CLASS 1 MODIFICATIONS TO THE HANFORD FACILITY RESOURCE
CONSERVATION AND RECOVERY ACT PERMIT (QUARTER ENDING
SEPTEMBER 30, 2007)

Hanford Facility RCRA Permit Modification Notification Forms

**Permit Attachment 4
DOE/RL-94-02, Hanford Emergency Management Plan**

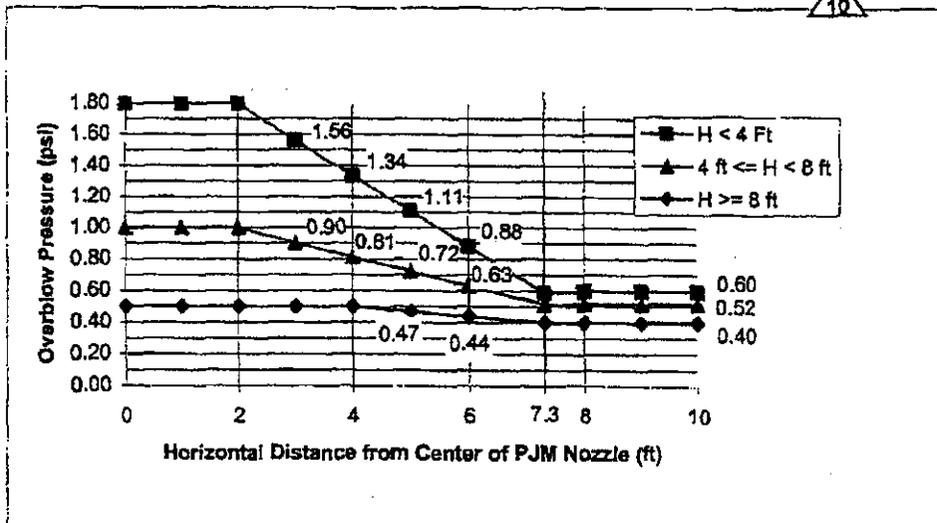
- Note 12: Revision 10 of this data sheet incorporates the GCN 129149. The GCN added the words "in the form of overflow presatble" to the notes shown above the overhead loads graph and further revised the note below the graph, as noted herein on sheet 3 of 5. Added calculation 24590-PTF-MTC-FRP-00001 and Environmental Qualification on Sheet 1. Added the note identified by "" on sheet 1.

Overflow loads vary as a function of the distance from the center of the overflowing pulse jet mixer nozzle and the elevation 'H' above the overflowing pulse jet mixer nozzle up to the overflow level, as plotted in the form of overflow pressures:

For all vessel internal components other than the overflowing pulse jet mixer, the overflow forces shall be applied a) in the vertical direction, and b) in the horizontal direction, radiating from the centerline of the overflowing pulse jet mixer. For the overflowing pulse jet mixer, the force shall be applied in the vertical upward direction only. The overflow force on all components, including the structures and supports, shall be calculated by applying the overflow pressure at the location of the nearest surface of the component and to the projected area of the component, facing the appropriate direction. The normal force component, specified for the normal pulse jet mixer operation condition, is not applicable to the overflow condition. Any single pulse jet mixer may overflow 1000 cycles. Reference CCN 125541 dated 07/27/05.

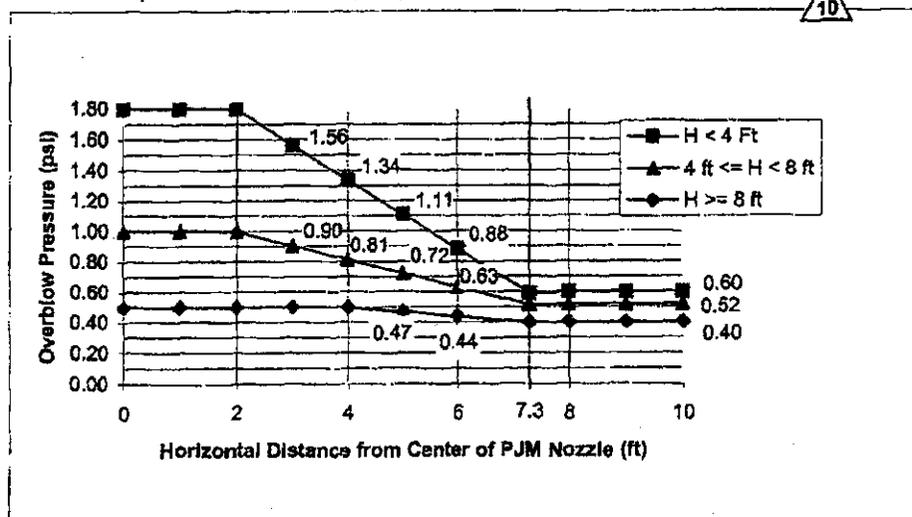
- Note 12:** Revision 10 of this data sheet incorporates the CCN 129149. The CCN added the words "in the form of overflow pressures", to the note shown above the overflow loads graph and further revised the note below the graph, as noted herein on sheet 3 of 3. Added calculation 24590-PTF-MTC-FRP-00001 and Environmental Qualification on Sheet 1. Added the note identified by ** on sheet 1.

Overblow loads vary as a function of the distance from the center of the overblowing pulse jet mixer nozzle and the elevation 'H' above the overblowing pulse jet mixer nozzle up to the overflow level, as plotted in the form of overblow pressures:

For all vessel internal components other than the overblowing pulse jet mixer, the overblow forces shall be applied a) in the vertical direction, and b) in the horizontal direction, radiating from the centerline of the overblowing pulse jet mixer. For the overblowing pulse jet mixer, the force shall be applied in the vertical upward direction only. The overblow force on all components, including the structures and supports, shall be calculated by applying the overblow pressure at the location of the nearest surface of the component and to the projected area of the component, facing the appropriate direction. The normal force component, specified for the normal pulse jet mixer operation condition, is not applicable to the overblow condition. Any single pulse jet mixer may overblow 1000 cycles. Reference CCN 125541 dated 07/27/05.

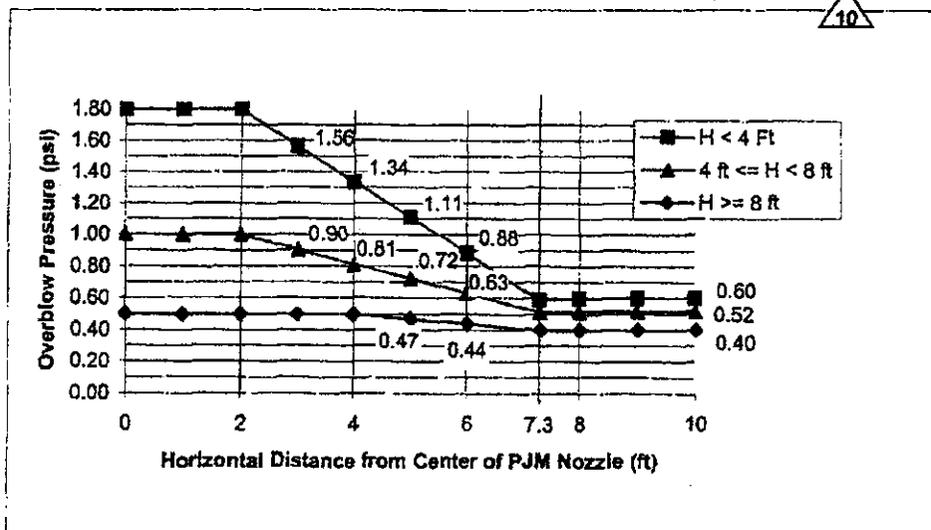
- Note 12:** Revision 10 of this data sheet incorporates the CCN 129149. The CCN added the words "in the form of overflow pressures", to the note shown above the overflow loads graph and further revised the note below the graph, as noted herein on sheet 3 of 5.

Overblow loads vary as a function of the distance from the center of the overblowing pulse jet mixer nozzle and the elevation 'H' above the overblowing pulse jet mixer nozzle up to the overflow level as plotted in the form of overblow pressures:

For all vessel internal components other than the overblowing pulse jet mixer, the overblow forces shall be applied a) in the vertical direction, and b) in the horizontal direction, radiating from the centerline of the overblowing pulse jet mixer. For the overblowing pulse jet mixer, the force shall be applied in the vertical upward direction only. The overblow force on all components, including the structures and supports, shall be calculated by applying the overblow pressure at the location of the nearest surface of the component and to the projected area of the component, facing the appropriate direction. The normal force component, specified for the normal pulse jet mixer operation condition, is not applicable to the overblow condition. Any single pulse jet mixer may overblow 1000 cycles. Reference CCN 125541 dated 07/27/05.

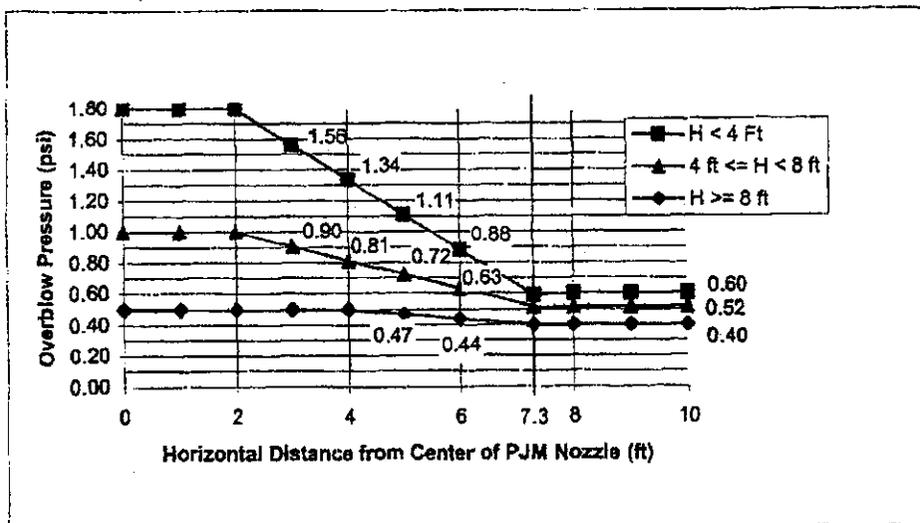
- Note 12:** Revision 10 of this data sheet incorporates the CCN 129149. ^{10/28/02} The CCN added the words "in the form of overflow pressures", to the note shown above the overflow loads graph and further revised the note below the graph, as noted herein on sheet 3 of 5. Added calculation 24590-PTF-MTC-FRP-00001 and Environmental Qualification on Sheet 1. Added the note identified by ** on sheet 1.

Overblow loads vary as a function of the distance from the center of the overblowing pulse jet mixer nozzle and the elevation "H" above the overblowing pulse jet mixer nozzle up to the overflow level, as plotted in the form of overblow pressures:

For all vessel internal components other than the overblowing pulse jet mixer, the overblow forces shall be applied a) in the vertical direction, and b) in the horizontal direction, radiating from the centerline of the overblowing pulse jet mixer. For the overblowing pulse jet mixer, the force shall be applied in the vertical upward direction only. The overblow force on all components, including the structures and supports, shall be calculated by applying the overblow pressure at the location of the nearest surface of the component and to the projected area of the component, facing the appropriate direction. The normal force component, specified for the normal pulse jet mixer operation condition, is not applicable to the overblow condition. Any single pulse jet mixer may overblow 1000 cycles. Reference CGN 125541 dated 07/27/05.

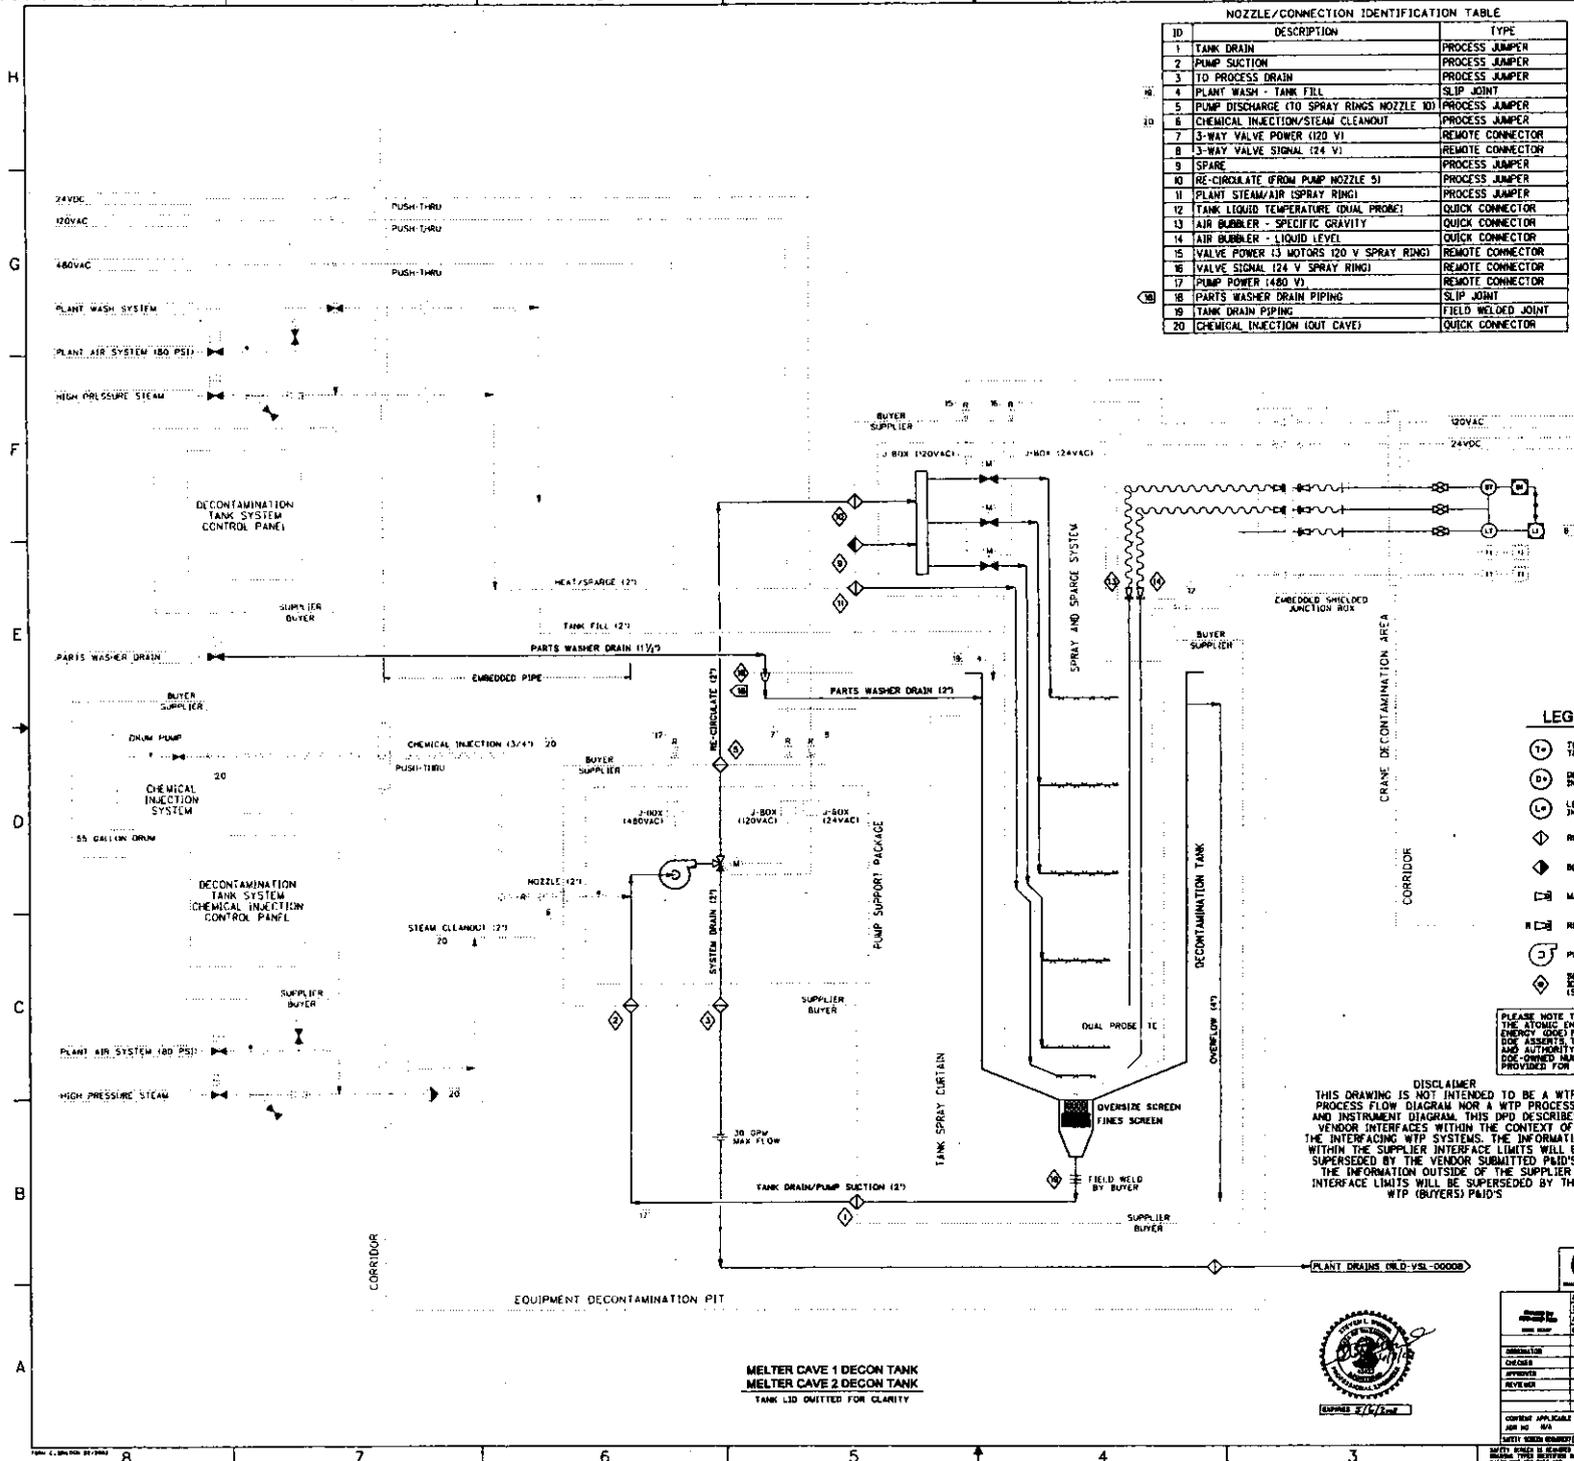
Page 2 of 2: Hanford Facility RCRA Permit, Operating Unit 10, Waste treatment and Immobilization Plant
Update HLW design proposal drawing 24590-HLW-M0-HSH-P0075, HLW Vitrification System HSH Melter
Cave 1 & 2 Design Proposal Drawing Decontamination Tank Process Flow Diagram, in Appendix 10.1 of the
Dangerous Waste Permit.

Figure 1 Melter Offgas System

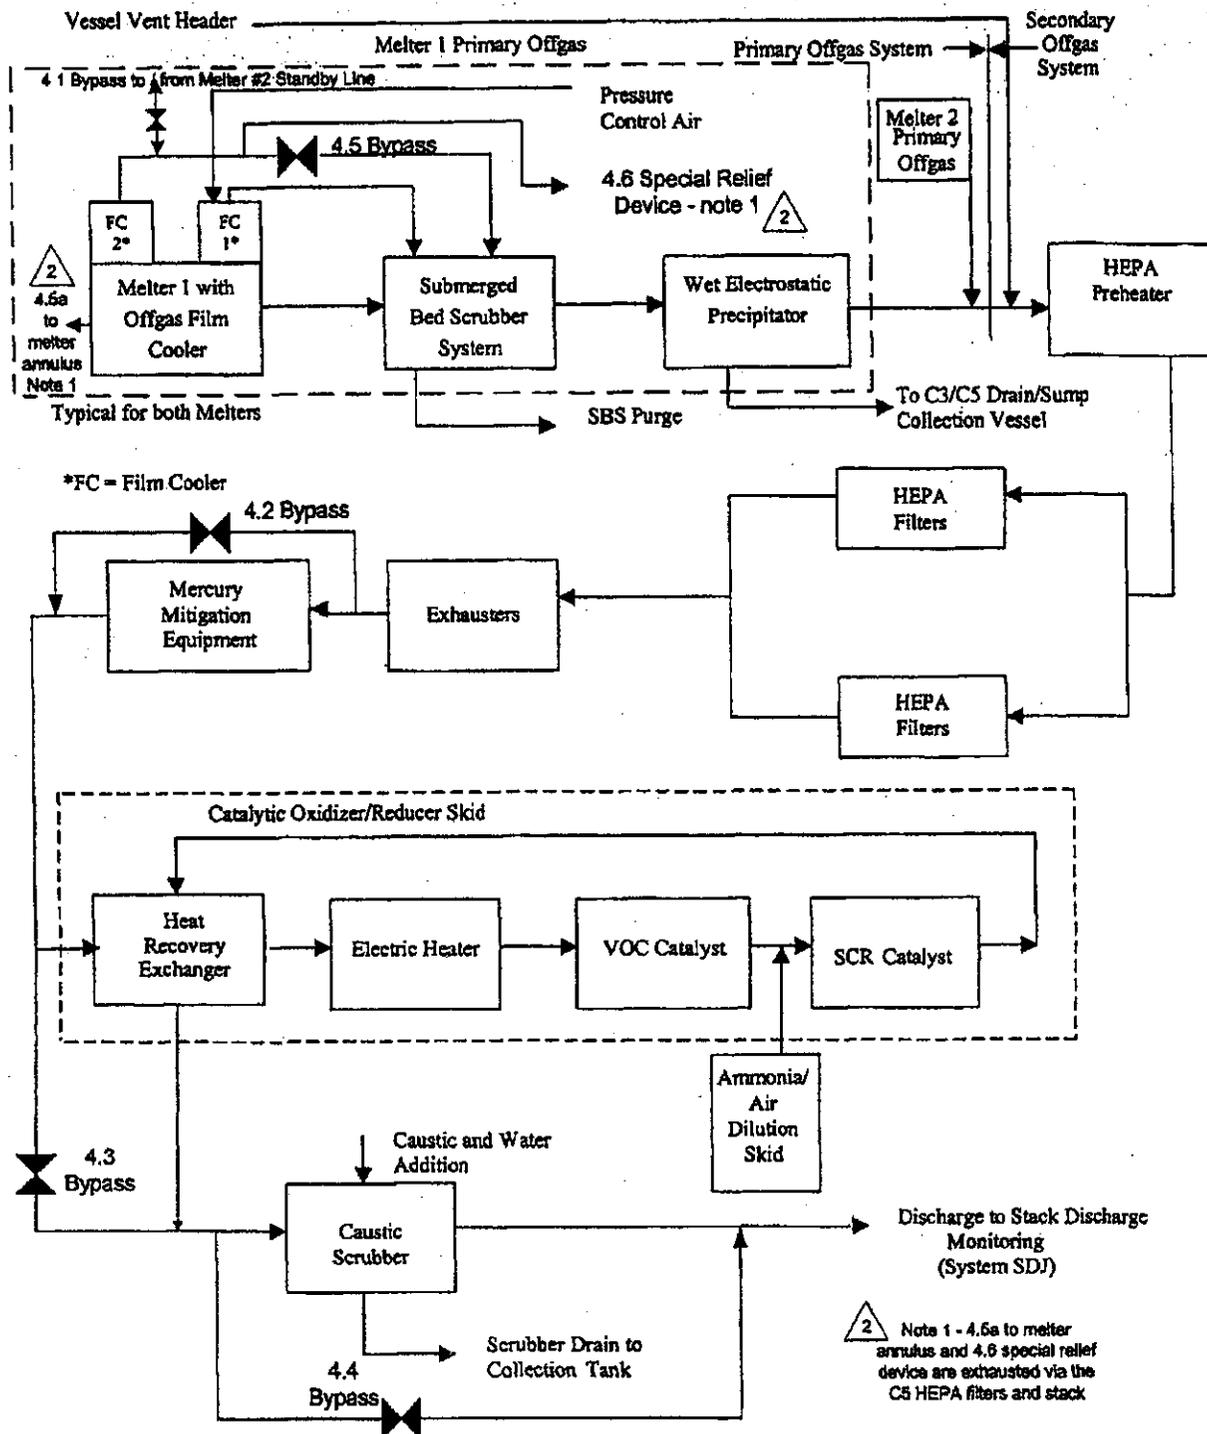
Rev	Date	Reason for revision	Revised by
0	28 January 2004	Issued for Permitting Use	T Anderson
1	7 February 2005	Updated and Issue for Permitting Use	R Hanson
2	9 May 2007	Updated section 4.5, 4.6 and Figure 1	R Hanson
